**RE-EVALUATION**  
of the  
**Environmental Assessment**  
**US 95 Northwest – Washington Avenue to Kyle Canyon**  
**Clark County, Nevada**

**FHWA-NV-EA 07.01**

December – 2012

**Project Name:** US 95 Northwest – Washington Avenue to Kyle Canyon Road

**Figure 1-7a Sound Wall S307 Not Required**

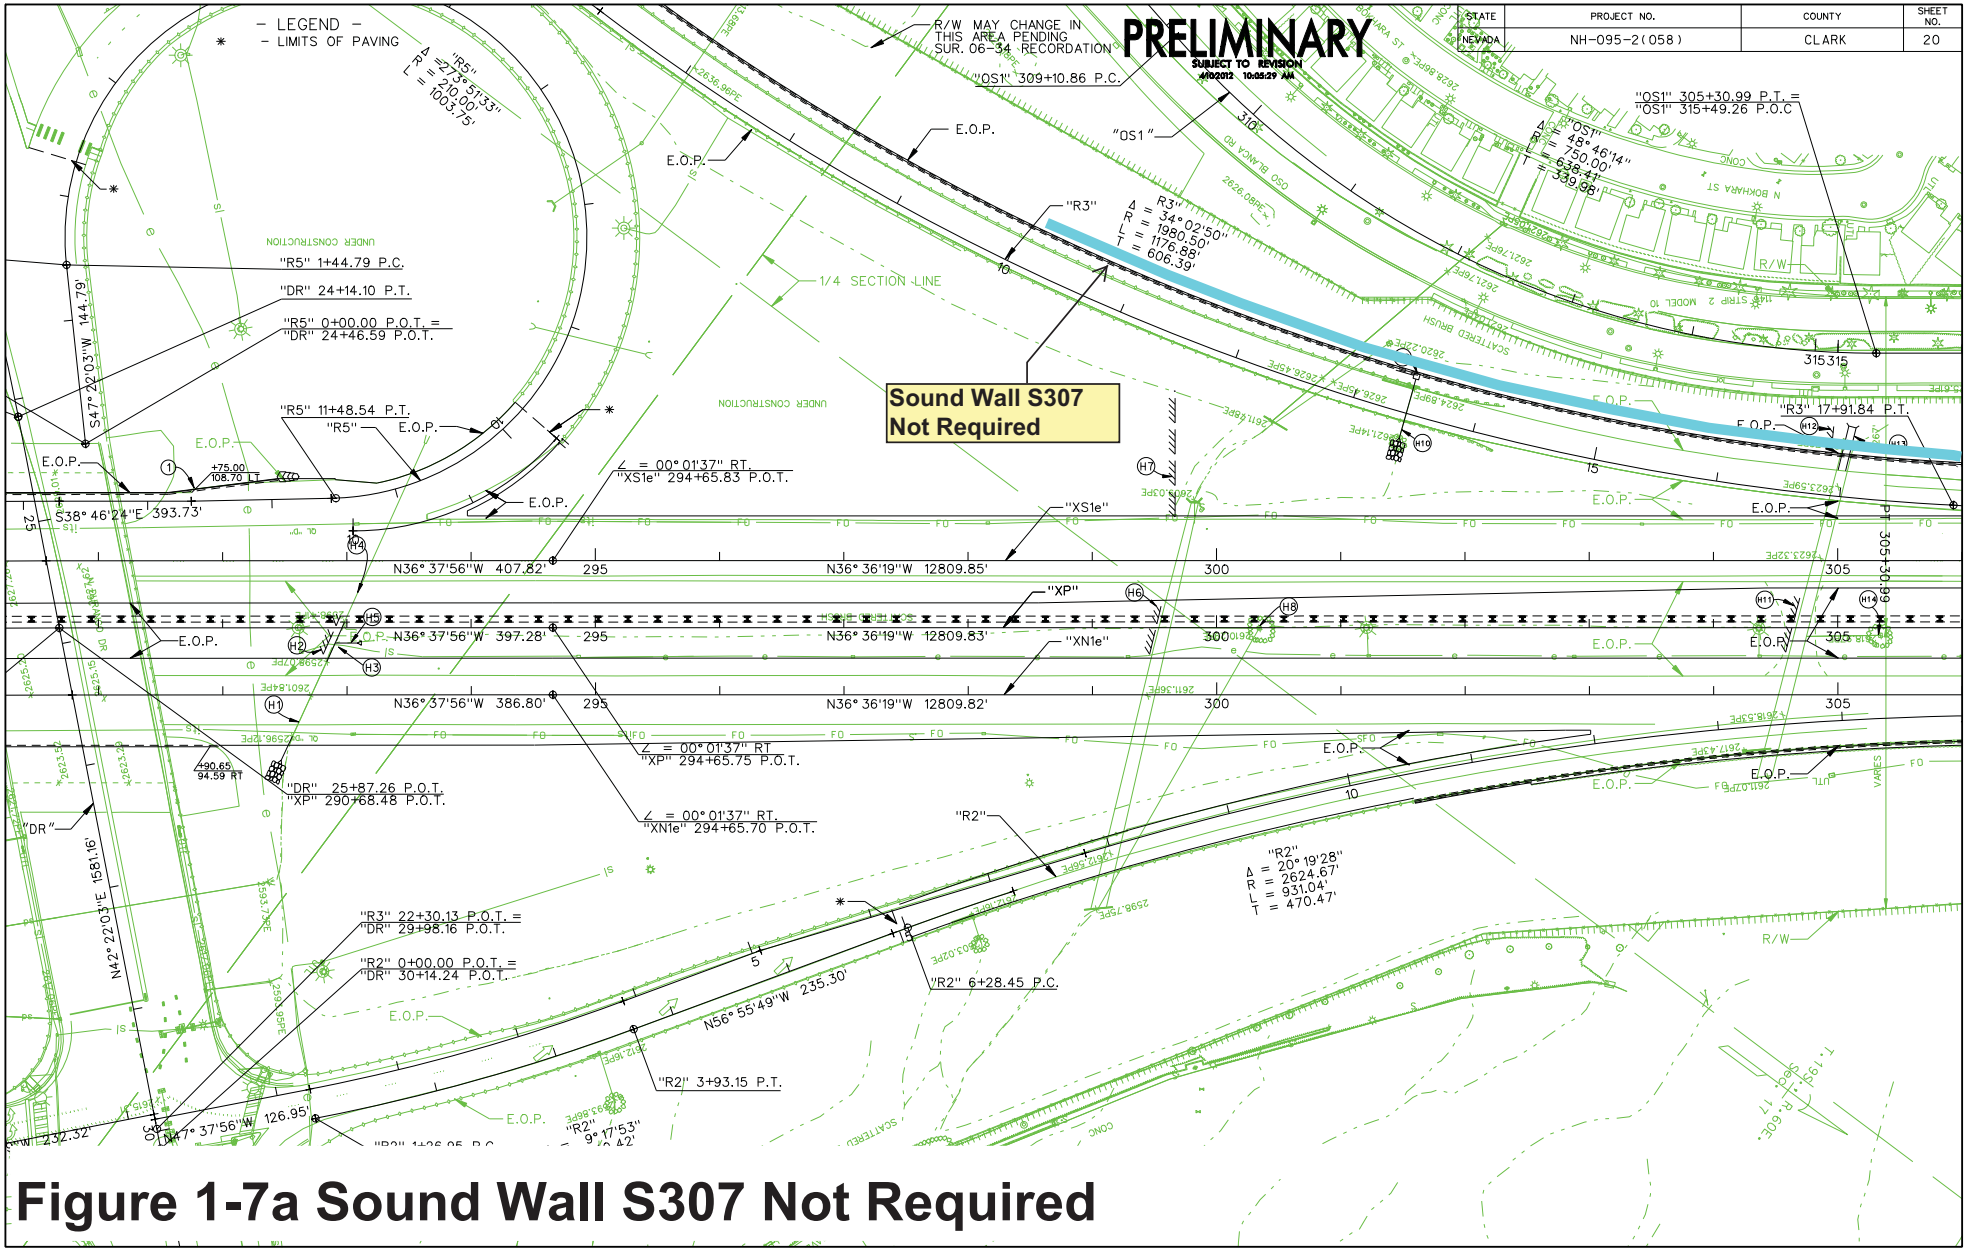
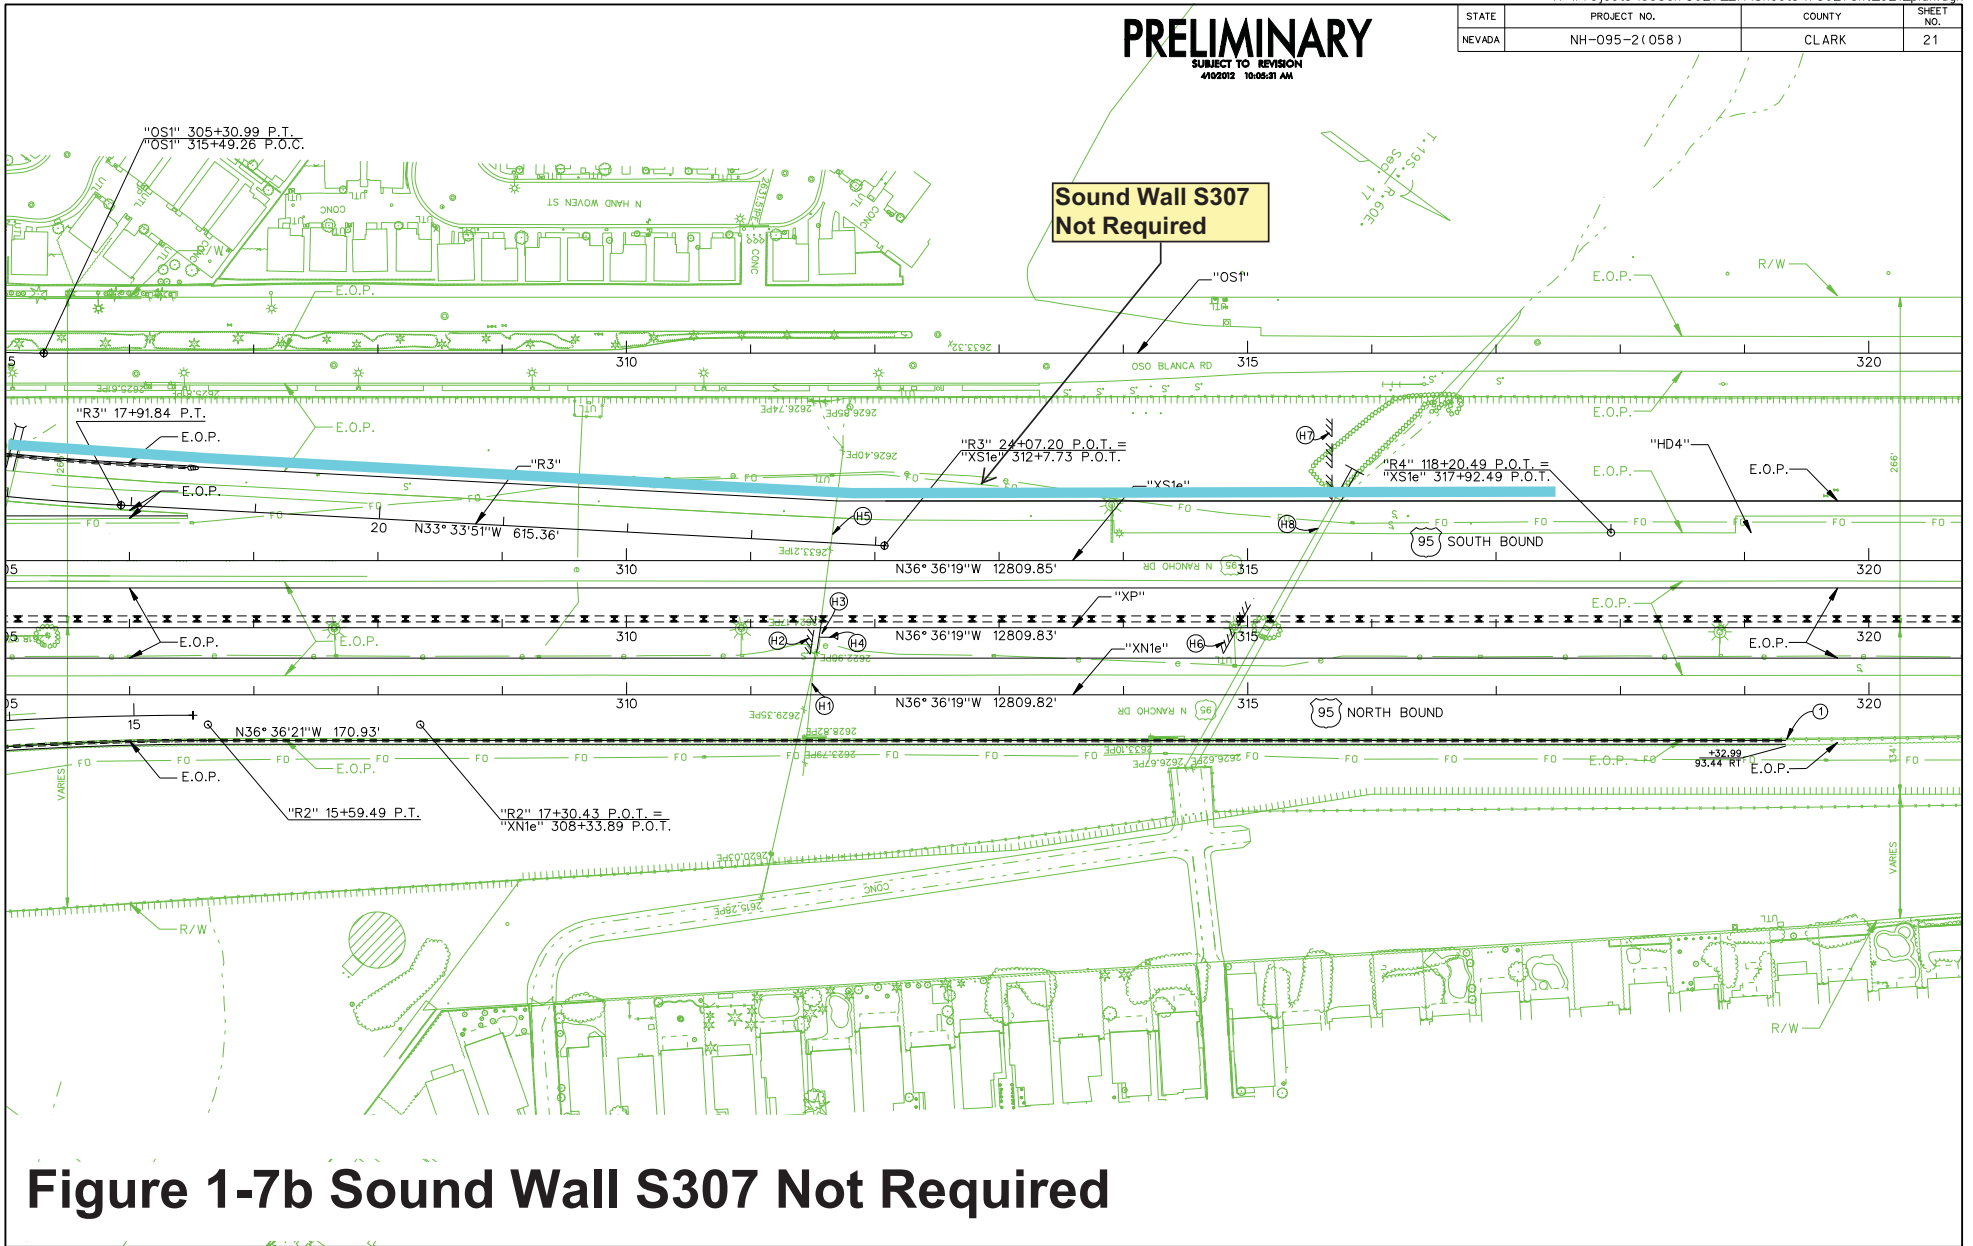
The proposed sound wall (S307) was located west of US95 and north of the Durango Drive interchange (*Figures 1-7a and 1-7b*). A request was made by NDOT Hydraulics Division to reposition the sound wall near the right-of-way fence due to required drainage improvements. Updated conditions were used in remodeling this sound wall and included definitive dimensions and location of a property/privacy wall shielding the identified residential development (Activity Category B). Analysis indicated predicted traffic noise levels were below the noise abatement criteria (NAC) and consideration of a traffic noise abatement measure was therefore not required. Further analysis was not required and sound wall S307 was not necessary.

**Figure 1-8 Eliminate Sound Wall S551 (LMRSW1)**

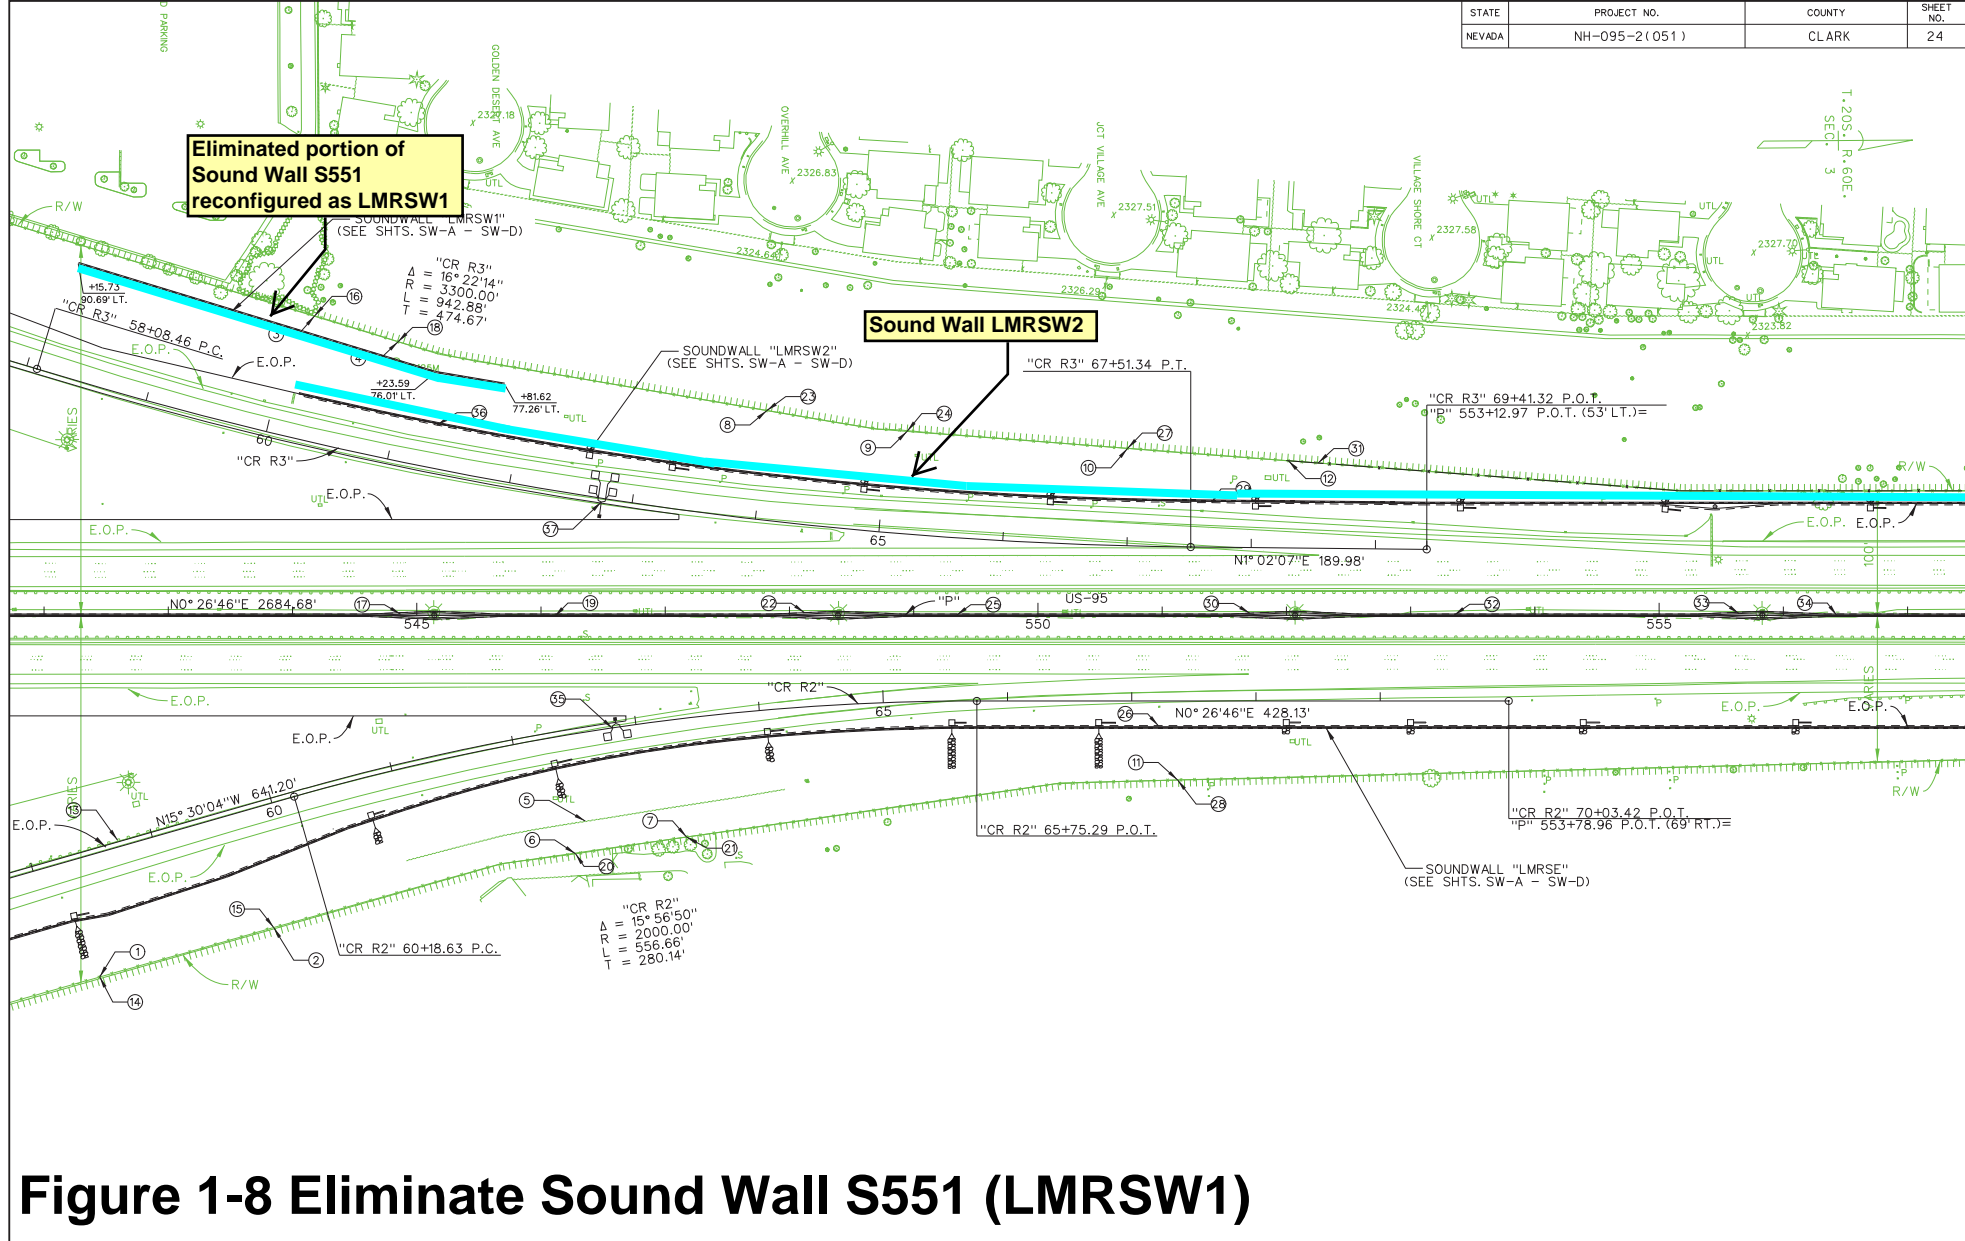
The sound wall (S551) located on the southbound exit ramp at Craig Road was reconfigured into two separate walls (LMRSW1 & 2) and offset for hydraulic purposes (*Figure 1-8*). The smaller, offset wall (LMRSW1) is a portion of the proposed S551 which would extend approximately 150' south, beyond a commercial property line. The commercial property owner requested NDOT not construct this additional 150'. The reconfigured sound wall was modeled, and it was determined that the shorter wall, LMRSW1 was not needed. The sound wall S551, reconfigured as LMRSW2, was acoustically feasible and provided a traffic noise abatement measure that reduces projected levels to below the noise abatement criteria (NAC) at the residential development (Activity Category B) north of the commercial property.
